September 26, 2002
NRC-02-0043

Subject: Proposed Technical Specification Change (License Amendment) –
Refueling Equipment Interlocks

**FERMI 2 NRC DOCKET NO. 50-341
OPERATING LICENSE NO. NPF-43**

**REQUEST TO REVISE TECHNICAL SPECIFICATION 3.9.1, REFUELING
EQUIPMENT INTERLOCKS**

3.9-1

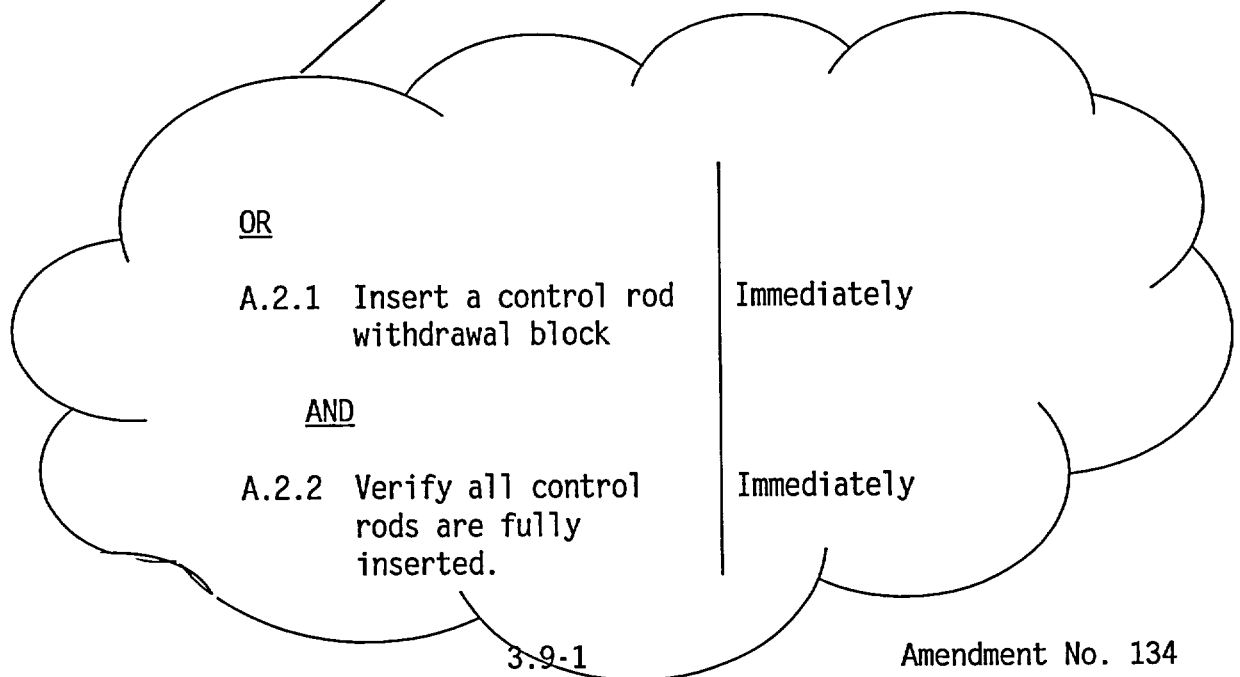
The proposed TS change would allow fuel movement to continue if the refueling interlocks were inoperable provided that a control rod withdrawal block is placed in effect (new Required Action 3.9.1.A.2.1) and that all control rods are verified to be fully inserted (new Required Action 3.9.1.A.2.2). These new Required Actions ensure that fuel loading will not occur with a control rod withdrawn. The approval of this TS would allow refueling activities to continue in the event of the failure of one or more of the refueling interlocks, while continuing to maintain a sufficient level of protection against inadvertent criticality. The change will be particularly beneficial during outages where refueling operations constitute critical path activities as a contingency provision for unexpected refuel interlock equipment problems.

The first refueling equipment interlock safety function is to block control rod withdrawal whenever fuel is being moved over or in the reactor vessel. The new Required Action 3.9.1.A.2.1 will perform this function by requiring that a control rod block be placed in effect continuously.

The second refueling equipment interlock safety function (fuel grapple or hoists loaded) is to prevent fuel from being loaded into the vessel when a control rod is withdrawn. This function will continue to be performed by the proposed alternate Required Actions in 3.9.1.A.2. Required Action 3.9.1.A.2.1 will require that a control rod block first be placed in effect, thereby ensuring that control rods are not subsequently inappropriately withdrawn. In addition, Required Action 3.9.1.A.2.2 will require that all control rods be verified to be fully inserted. This verification is in addition to the periodic requirement to verify control rod position every 12 hours specified in TS 3.9.3, Control Rod Position, SR 3.9.3.1. These proposed Required Actions will ensure that control rods are not withdrawn and cannot be inappropriately withdrawn, because an electrical or hydraulic block to prevent control rod withdrawal will be in place. Like Required Action 3.9.1.A.1, proposed Actions 3.9.1.A.2.1 and 3.9.1.A.2.2 will ensure that unacceptable operations

| CONDITION | REQUIRED ACTION | COMPLETION TIME |
|--|---|-----------------|
| | A.2.1 Insert a control rod withdrawal block | Immediately |
| | A.2.2 Verify all control rods are fully inserted. | Immediately |
